**COMMUNITY DEVELOPMENT
DEPARTMENT REPORT**

HEARING DATE: 10/3/2024
TO: Planning & Zoning Commission
FROM: Nick Napoli, Associate Planner
208-884-5533
nnapoli@meridiancity.org
APPLICANT: Connor Lindstrom
SUBJECT: H-2024-0035
Ziggi's Coffee
LOCATION: 4801 S. Tavistock Avenue, in the North 1/2 of Section 33, T.3N., R.1E. (Parcel #R3636010020)

E. Landscape Plan (date: 8/15/2024)

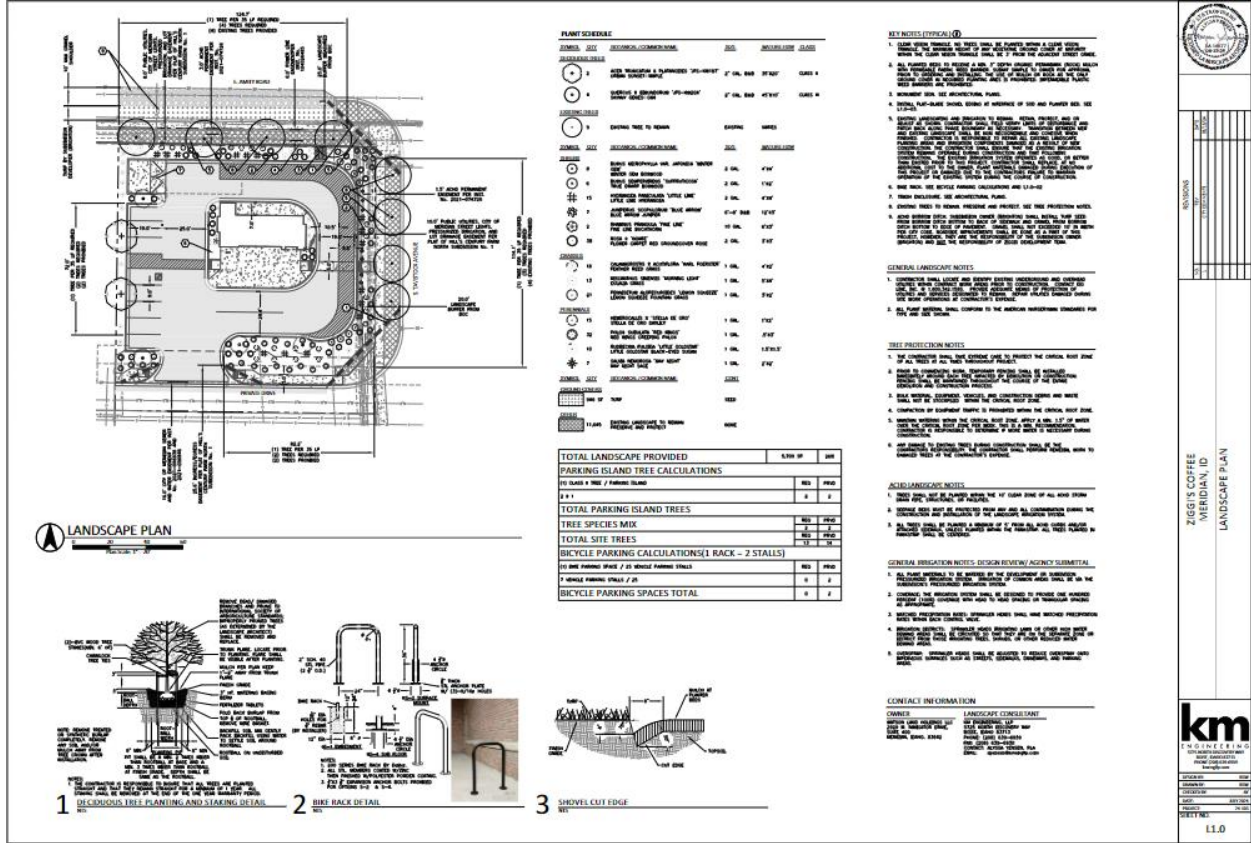
Landscaping is required to be provided along all parking areas per the standards listed in UDC 11-3B-8. *The proposed landscape plan does not meet the minimum requirements. The west landscape buffer shall be widened to 7 feet and the parking stall shall be reduced to 17 feet. An alternative to this is redesigning the site to abut parking with the adjacent property to the west.*

Landscaping is required to meet the standards of UDC 11-3B-9. *The landscape plan should be revised to ensure there is 70% vegetation coverage at maturity.*

Storm drainage is required to comply with the standards listed in UDC 11-3A-18. *Drainage swales should not be within the landscape setbacks along E. Amity Road.*

- ii. The west landscape buffer shall be widened to 7 feet and the parking stalls shall be reduced to 17 feet. An alternative to this is redesigning the site to abut parking with the adjacent property to the west.

- iii. The west landscape buffer shall include more vegetation as it currently does not meet 70% vegetation coverage at maturity in accord with UDC 11-3B-5-N

- iv. The landscape buffer along Amity Road shall be extended to the curbing in accord with UDC 11-3B-7.

F. Building Elevations (date: 7/2/2024)

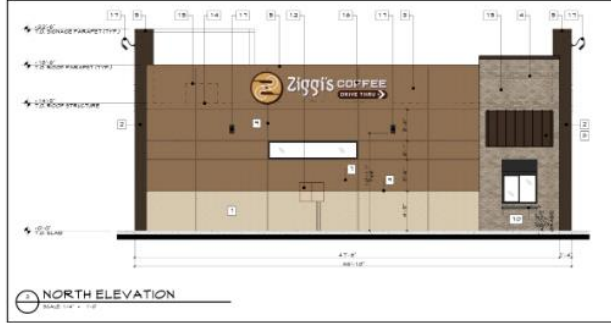
Staff recommends the incorporation of more fenestration and glazing on the North façade as this is the primary façade that is visible from E. Amity Road. The proposed conceptual elevations are not approved. The final design is required to comply with the Architectural Standards Manual for Commercial Design Guidelines.

5. Business hours of operation within the C-N District shall be limited from 6:00 a.m. to 10:00 p.m.
 6. Provide additional fenestration and glazing on the north façade facing E. Amity Road.
